Sheet No. A	06-13-2014	A00572887	9097507288-M1	
Ed	Page	Modified from	Date	Inv./Appt	Parent 3D model
					Ed Version 3D

Scale	1:10	Project	AS-configure (102547183)	Issued	2015-10-26
Drawn by	mlk244	Drawn on	Replaces	Revised	
Version Being		Scale set	40' on set	11 071 103	Designation
Date Issued		Print released	Approved	Date	26-10-2015
Pending

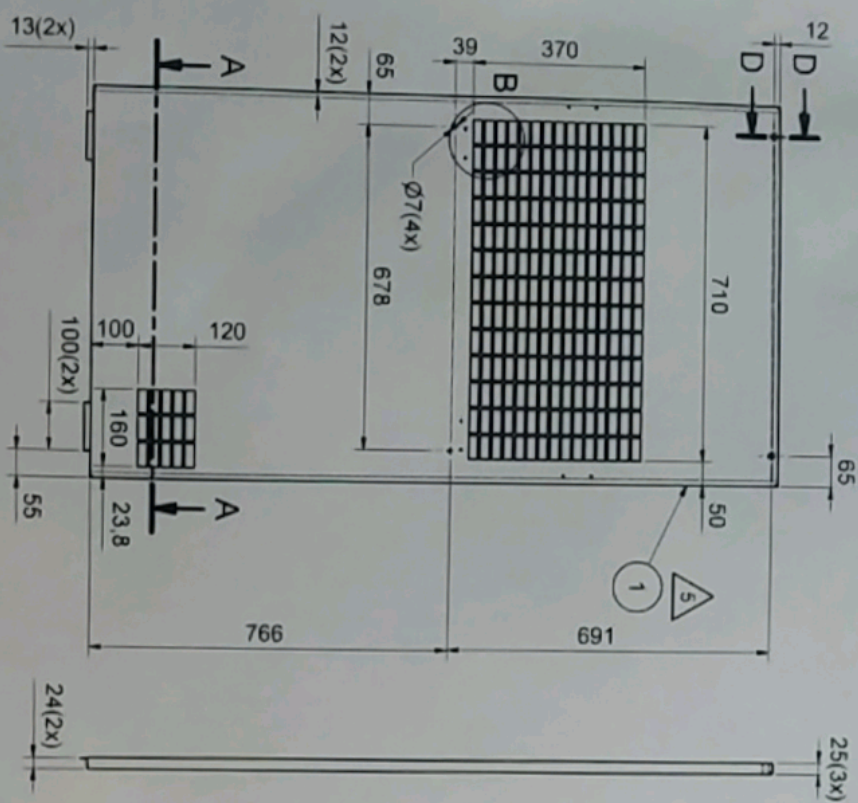
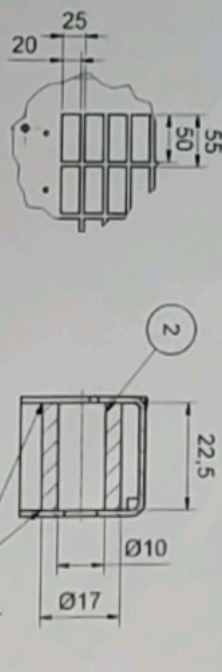
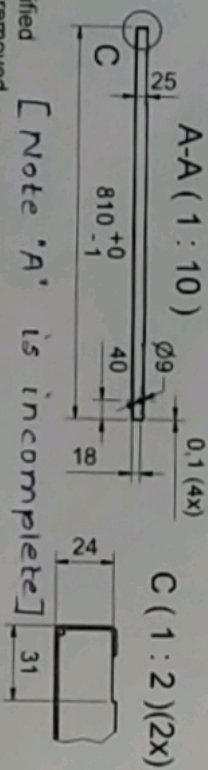
[Dimensions are incomplete]

[Add secure of detailed view 'B']

[Isometric view is missing]

[welding data is

[Add part-1ist]

[Note 'A' is incomplete]

[Specify revision no.]

[illegible]
